# Product Change Notification

PCN22-12\_ JS Series\_25 PNs: Contact Plate Design Change

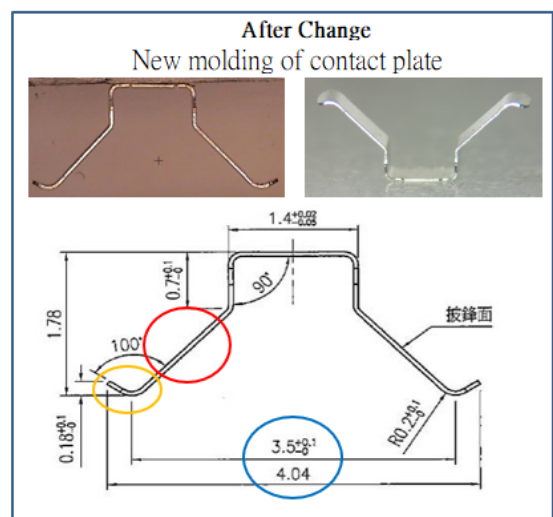
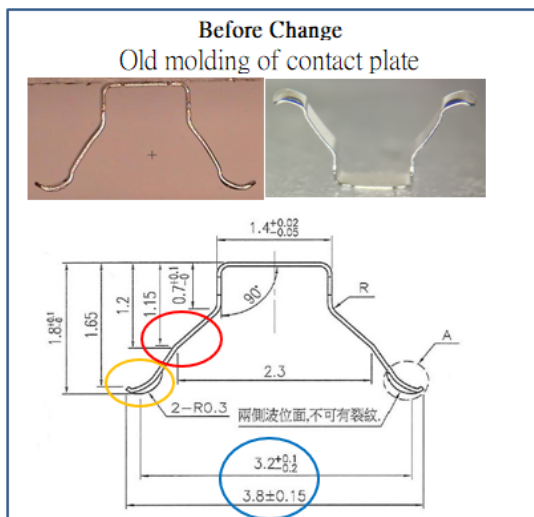
Point 1 (shown in the orange circles): The change from spherical contact to surface contact makes the contact area between the contact plate (movable contact) and the base (fixed contact) increase (from point contact to surface contact), which could decrease the wearing of contacts when sliding and have more stable contacts. Please refer to the life test report for this point.

Point 2 (shown in the red circles): The straight shape changed from the arc shape of the contact plate is more stable and the dimensions are more accurate to control/measure in the production process.

Point 3 (shown in the blue circles): The dimensions in the blue circles are adjusted accordingly to match the new design of the above structural changes. The travel distance between the contact plate (movable contact) and the base (fixed contact) should be more stable.
